Rezoning Application: PD 25-1386
Zoning Hearing Master Date: March 23, 2026
BOCC Land Use Meeting Date: May 12, 2026

APPLICATION NUMBER:	PD 25-1386	
ZHM HEARING DATE:	March 23, 2026	
BOCC LUM MEETING DATE:	May 12, 2026	Case Reviewer: Michelle Heinrich, AICP

**GENERAL
SITE PLAN
FOR
CERTIFICATION**

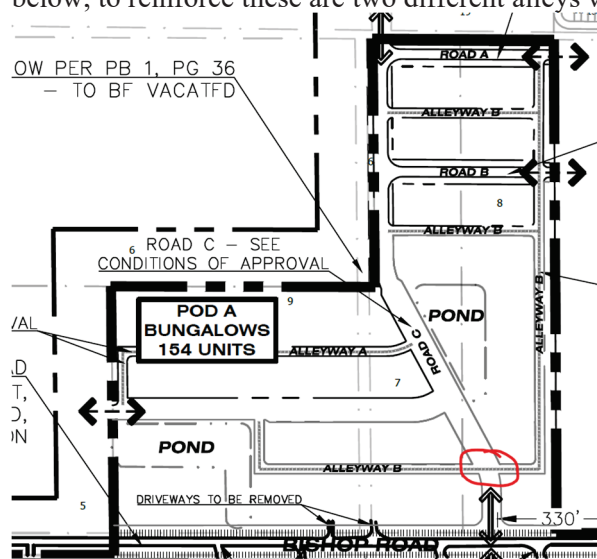
- Prior to PD Site Plan Certification, the developer shall revise the PD site plan to:
 - Remove lettered alleyway designations from those three (3) alleyways highlighted below, and instead label as “Alleyway”. Staff notes these alleyways are not subject to the special alley typical section standard for lettered alleys, due to the lots they serve having frontage on a roadway meeting Transportation Technical Manual (TTM) standards;

- Remove the line connecting two different alleys which goes across Road C, as indicated below, to reinforce these are two different alleys with different standards.

FIGURE 2: PROPOSED TYPICAL SECTION

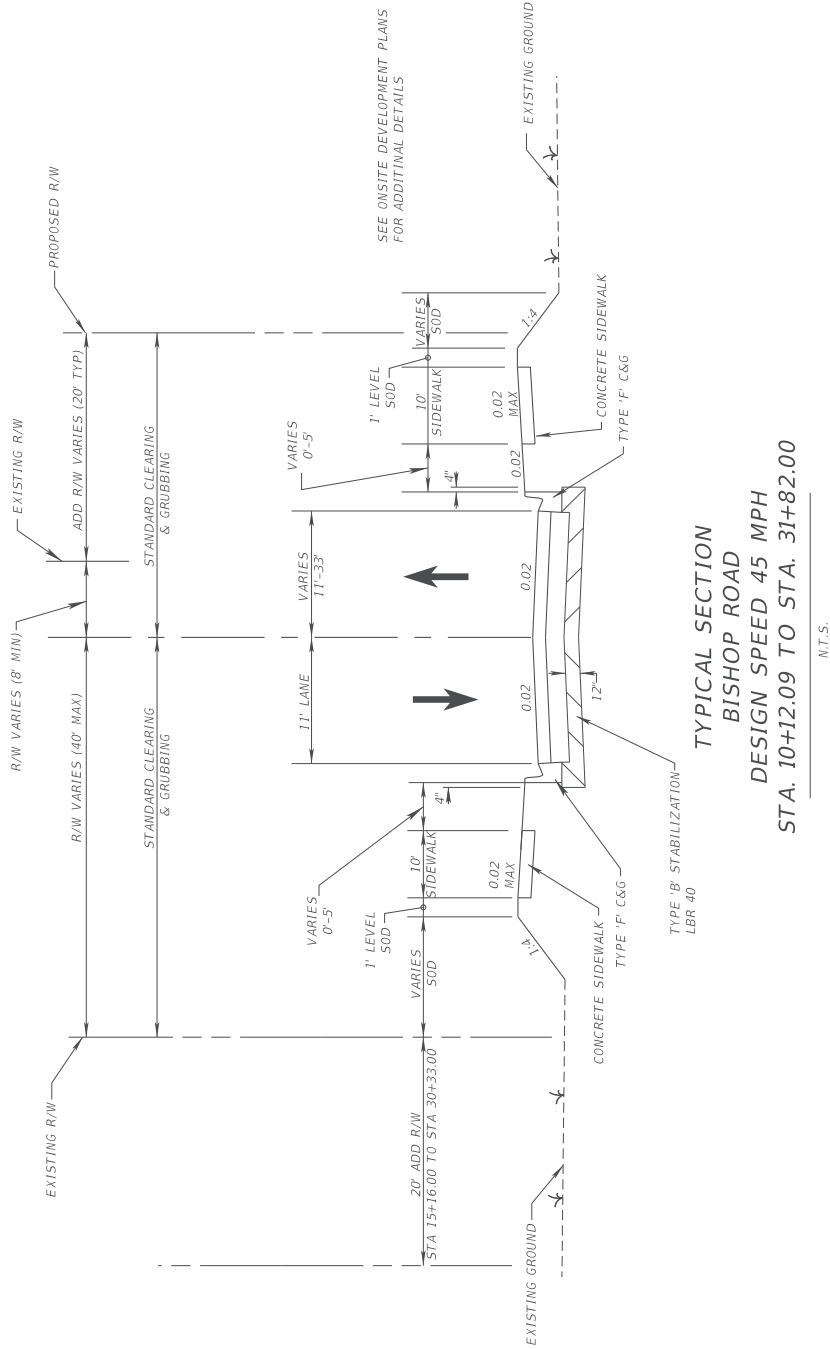
This request is a design exception to the Hillsborough County Transportation Technical Manual for Bishop Road from West Lake Drive to its current east/west terminus, approximately 2,100 feet to the east. The requested exceptions to the TS-4 typical section and the justification are as follows:

1. The typical TS-4 section for a collector, two-lane undivided roadway requires a minimum of 64 feet of ROW with 11-foot travel lanes, 7-foot buffered bike lanes, F type curb, 5-foot grass strip and 5-foot sidewalks.
2. The request is to provide 11-foot travel as outlined in the TS-4.

3. The request is not to provide the 7-foot buffered bike lanes, but to provide a multi-use path instead. This would be consistent with the West Lake Drive typical section that is already under construction.
4. The request is to provide the F type curb as outlined in the TS-4.
5. The request is to reduce the grass strip between the back of curb and the sidewalk from 8 feet to a minimum of 0 feet and a maximum of 5 feet depending on constraints.
6. The request is to provide a 10-foot multi-use path in lieu of the required 5-foot sidewalk on both sides of Bishop Road. The multi-use path will serve both bicycle and pedestrian traffic along Bishop Road.
7. The improvements included in the request are accomplished with a ROW dedication of approximately 20 feet.

FIGURE 2: ACCESS SPACING

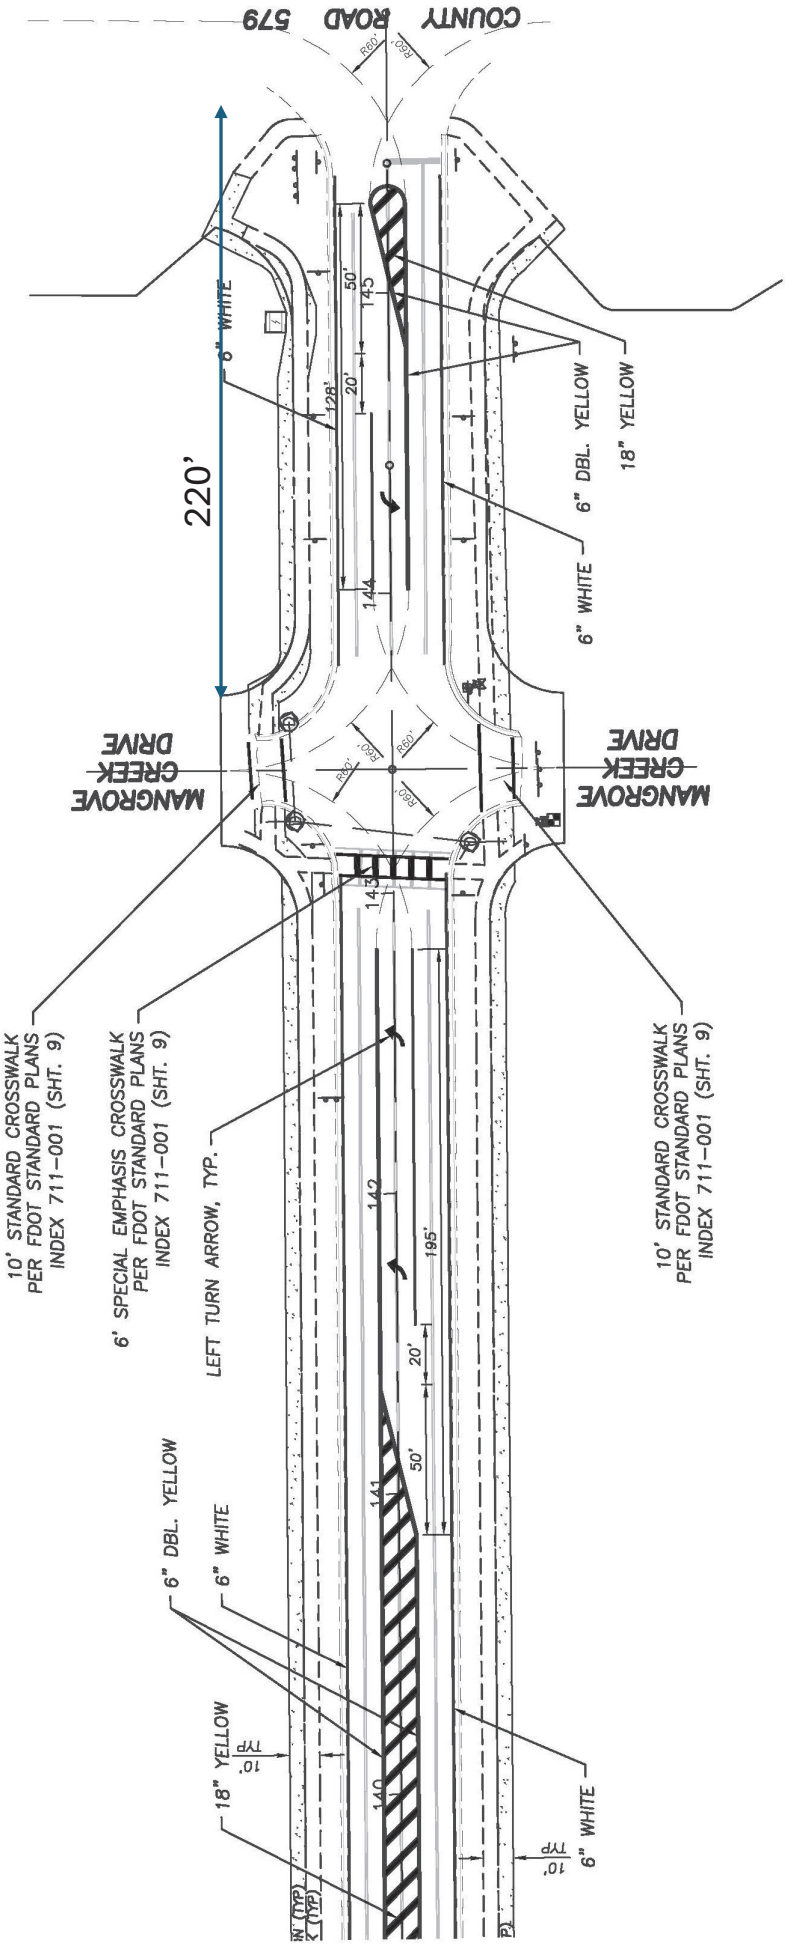
Bishop Road is identified in the Hillsborough County Functional Classification Map as a Collector roadway and has a posted speed limit of 25 mph. The request is for an Administrative Variance to Section 6.04.07 of the Hillsborough County LDC for the access spacing for the full access (easternmost access) to Bishop Road. Based on Section 6.04.07, the connection spacing for Bishop Road is 245 feet for a Class 6 road. Figure 2 illustrates the proposed driveway locations relative to the existing driveway location.

The access spacing variance is requested to maintain the full access driveway to Bishop Road for this development which has already been constructed. Without the variance, reasonable access to the property could not be provided.

TYPICAL SECTION
WEST LAKE DRIVE
NTS

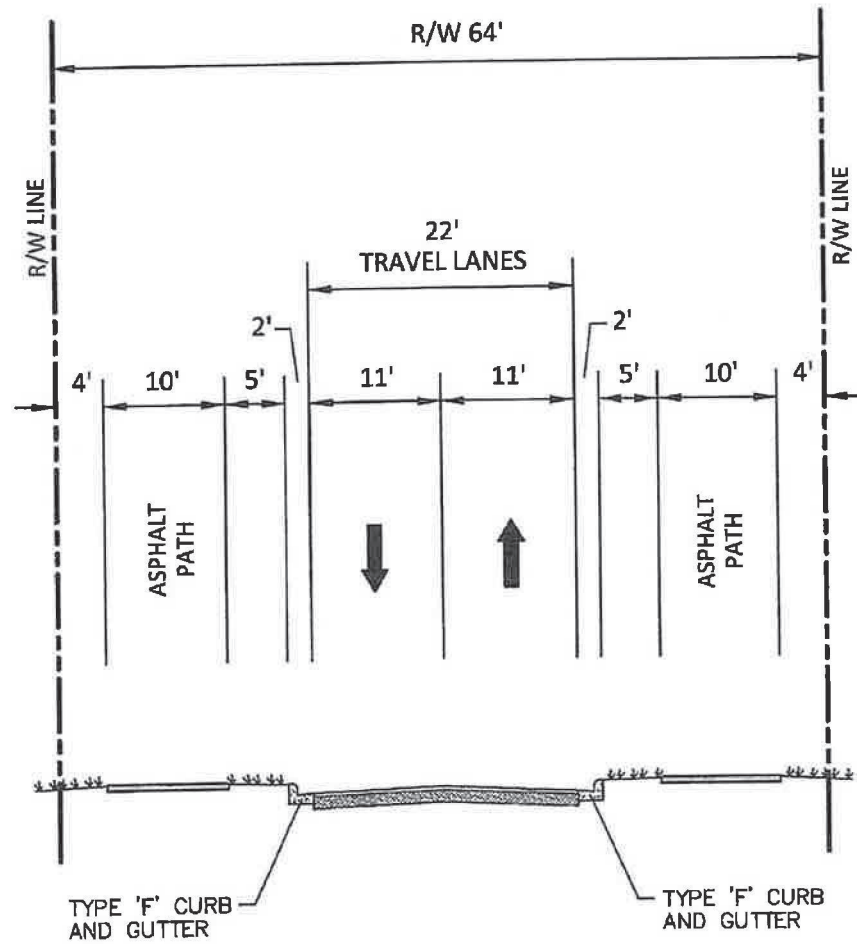
The developer proposes two alternative sections. The first is where there is sufficient right of way to provide the proposed section which is shown in Figure 1. Figure 2 illustrates the

proposed section where right of way is limited and/or there are design constraints. The primary difference in these sections is the distance from the back of the curb to the sidewalk. It should be noted that the distance between the back of the curb and sidewalk can vary depending on the right of way and roadway constraints. This section will be minimized to the greatest extent feasible. The sections include the following:

1. Bike Lanes – Due to the three schools that are proposed along West Lake Drive, 10 foot sidewalks are proposed on each side of West Lake Drive in lieu of the bike lanes. From a safety standpoint, the 10 foot sidewalks provide a better option for students walking and riding bikes to school than students riding bikes within West Lake Drive or pedestrian and bikes on a 5 foot sidewalk. Due to right of way constraints along the roadway, it is not feasible to provide the bike lanes and the 10 foot sidewalks.
2. Sidewalk – 10 foot sidewalk on both sides of the roadway are proposed instead of the bike lanes. As stated above, given the roadway will serve the three (3) schools, the 10 foot sidewalks provide a better option for the school students.

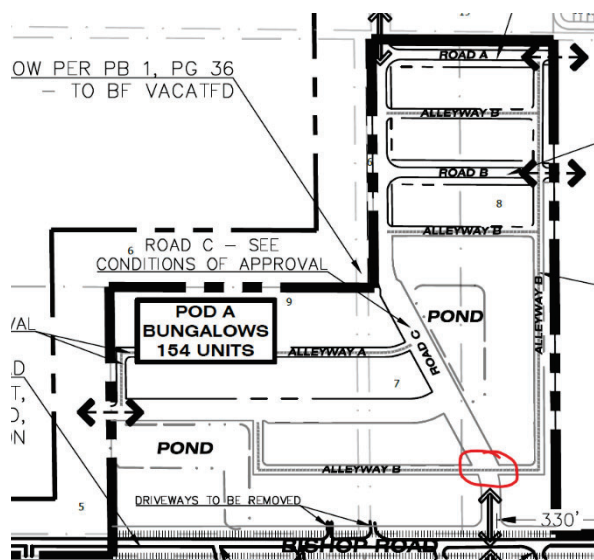
1. Remove lettered alleyway designations from those three (3) alleyways highlighted below, and instead label as "Alleyway". Staff notes these alleyways are not subject to the special alley typical section standard for lettered alleys, due to the lots they serve having frontage on a roadway meeting Transportation Technical Manual (TTM) standards;

2. Remove the line connecting two different alleys which goes across Road C, as indicated below, to reinforce these are two different alleys with different standards.
